Service Bulletin

SB 80-6 1-29-79

HORNS

308 GTB (U.S.A. VERSION)

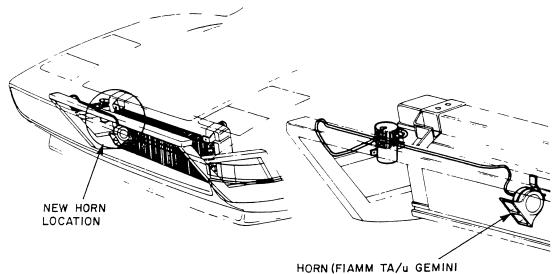
Sound of the horn is too loud inside the passenger compartment.

Location of horn

Installation of a new type horn, ("FIAMM TA/U Gemini") and mounting bracket to the center of the upper front frame bar. (See illustration.)
